Docket Number:	08-AFC-04C
Project Title:	Orange Grove Energy Project - Compliance
TN #:	202969
Document Title:	Petition to Amend the California Energy Commission Decision for the Orange Grove Power Project (08-AFC-4C)
Description:	N/A
Filer:	Walter Rusinek
Organization:	Procopio, Cory, Hargreaves & Savitch LLP
Submitter Role:	Applicant Representative
Submission Date:	8/21/2014 2:24:35 PM
Docketed Date:	8/21/2014

Re: Petition to Amend the California Energy Commission Decision for the
Orange Grove Power Project (08-AFC-4C)

These comments on the “Petition to Amend the California Energy Commission Decision for the Orange Grove Power Project (08-AFC-4C)” (“Petition”) are provided to the California Energy Commission (“CEC”) on behalf of our client, the Pala Band of Missions Indians (“Pala Band”). The Pala Band is a federally recognized Native American Tribe, and a sovereign government entity.

Figure 6.5-4
 100-Year Flood Zone
 Orange Grove Project
 San Diego County, CA

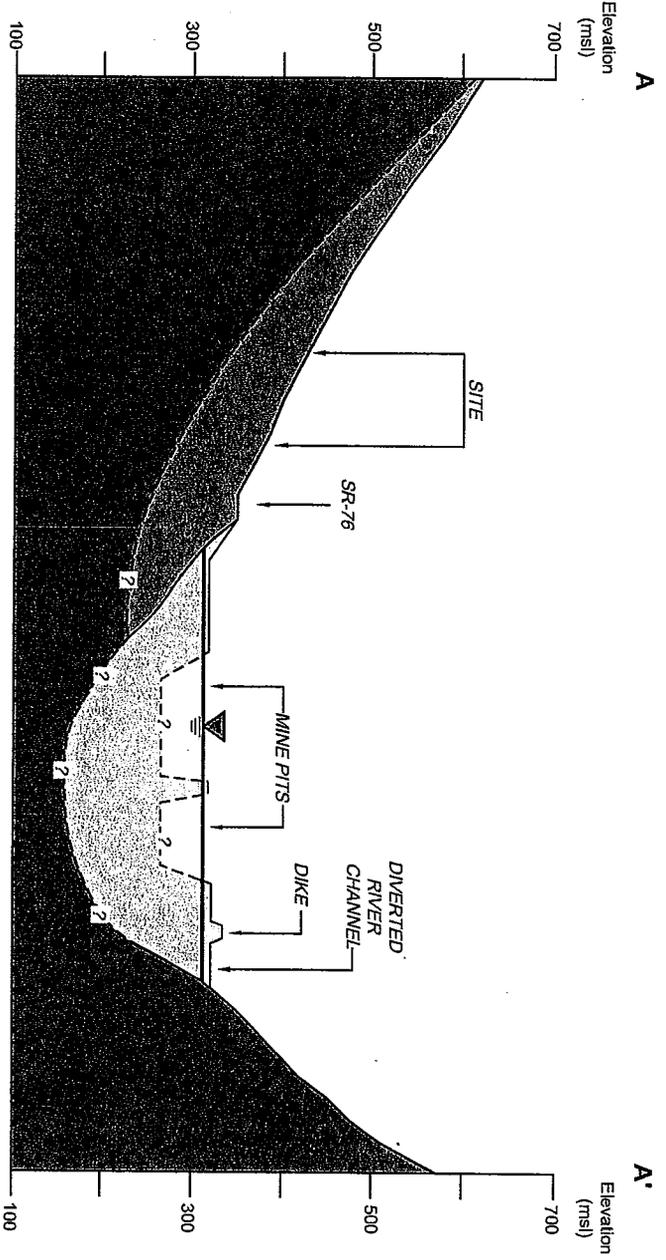
For example, Figure 6.5-4 of the Application showed that the Power Plant Parcel is not within the 100-year flood zone, which the figure shows is located entirely south of SR 76 on the Pala Property. (Exhibit K). That is evidence that the Power Plant Parcel is not riparian to the surface flow of the San Luis Rey River and that even in very high flows, water from the river does not touch the Power Plant Parcel.

PROJECT: 125158	HYDROGEOLOGIC CROSS SECTION A-A'
	FACILITY: ORANGE GROVE PROJECT SAN DIEGO COUNTY, CALIFORNIA	
FIGURE 6.5-5

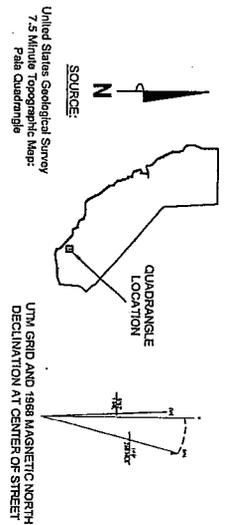
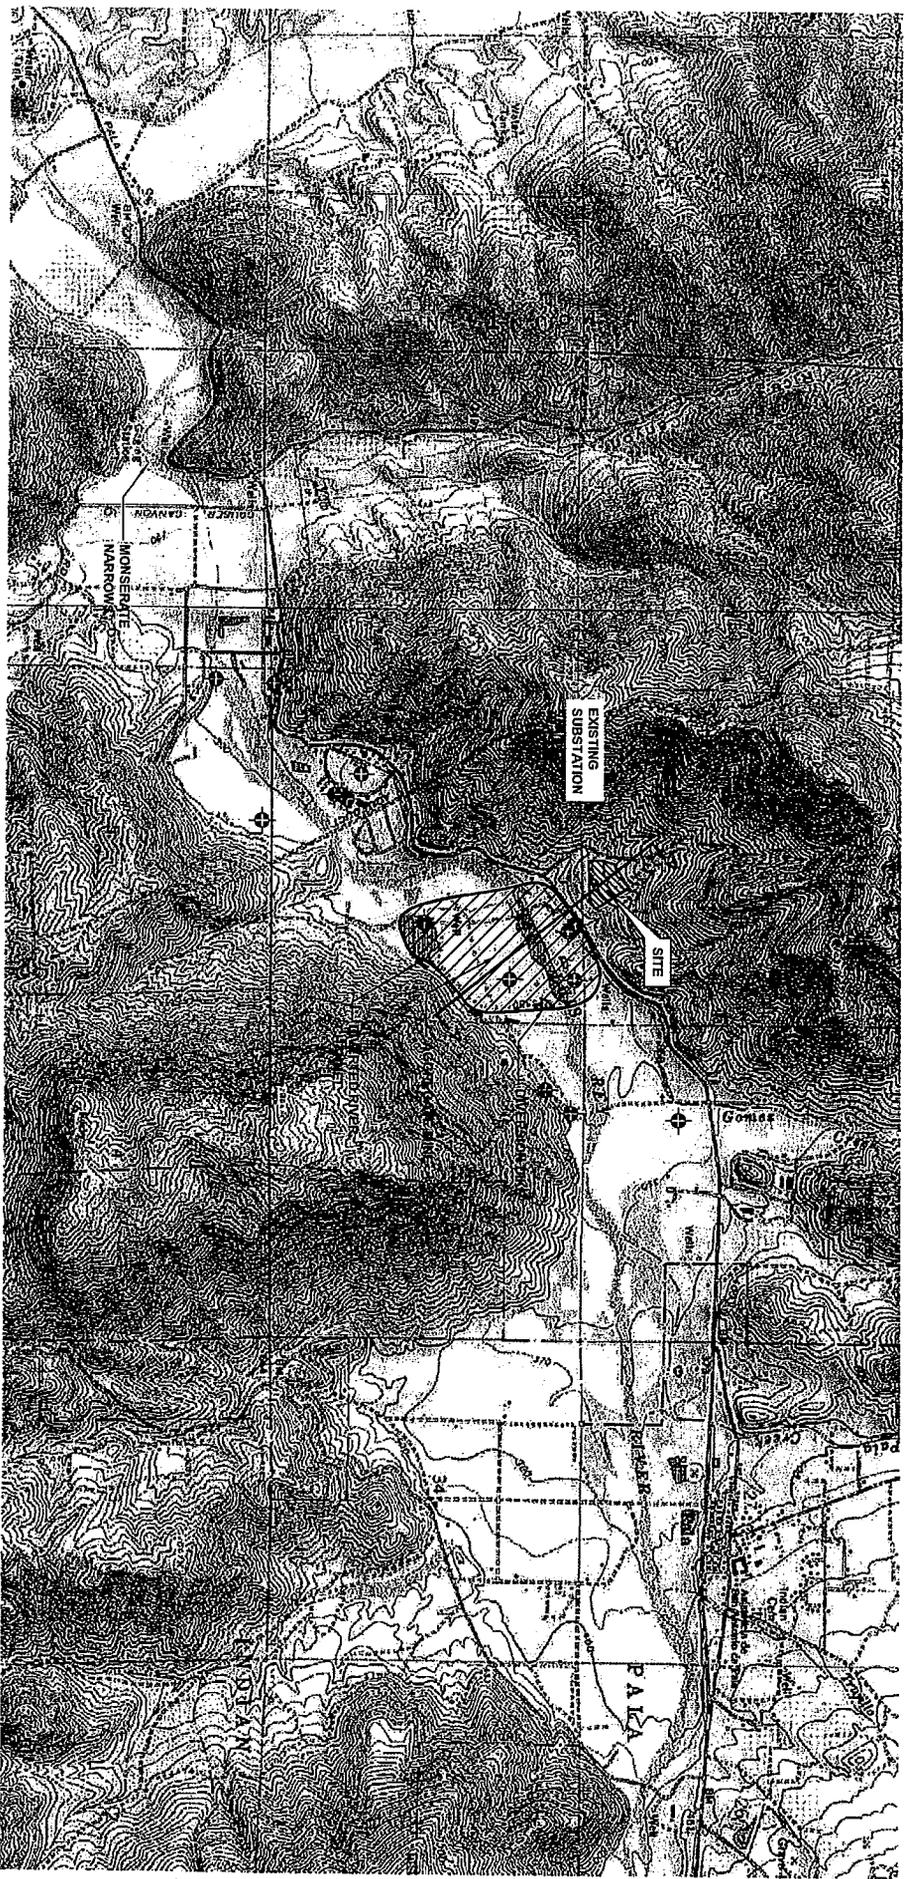
As to the subterranean stream, Figure 6.5-5 of the Application provides a hydrogeologic cross-section of the area where the Pala Property and the Power Plant Parcel are located. (Exhibit L). The location of the cross-section included in Figure 6.5-5 is identified on Figure 6.5-2 of the Application, which is also included in Exhibit L. Figure 6.5-2 shows that the cross-section depicted on Figure 6.5-5 runs through the Pala Property and directly across the area where the Power Plant is located.

The cross-section reflected in Figure 6.5-5 shows the subterranean stream (the Pala Basin alluvium) in a gold color, which the figure identifies as the "water-Bearing"

alluvium. Figure 6.5-5 also shows that the “water-Bearing” alluvium is located entirely on the south side of SR 76. Conversely, the Power Plant Parcel (identified as the “Site” on the graphic) is shown to be underlain by “Very Old Alluvium” that is “Not Water-Bearing.” Both areas are underlain by the “Plutonic Basement Rock.”

The conclusions stated in the Application and shown graphically on Figure 6.5-5 that the subterranean stream does not abut the Power Plant Parcel were confirmed by the installation of a test well on the Power Plant Parcel in September of 2013 by TRC Solutions (“TRC”). TRC also had prepared the Application, other certification documents, and the Figures discussed above. The test well was installed to a depth of approximately 75 feet below ground surface (“bgs”) on the edge of the Power Plant Parcel close to SR 76. (Exhibit M at 1, Figure 2).

The TRC test well confirmed what Figure 6.5-5 shows: the Power Plant Parcel does not abut the subterranean stream. As a result, SDGE as the owner of the Power Plant Parcel does not have the right as a riparian owner to divert water from the SDGE well for use on that parcel. Instead, SDGE or OGE must obtain an appropriative rights permit from the State Board in order to divert water from the SDGE well for use on the Power Plant Parcel. That this issue was not addressed in the Petition is a fatal flaw in the analysis.
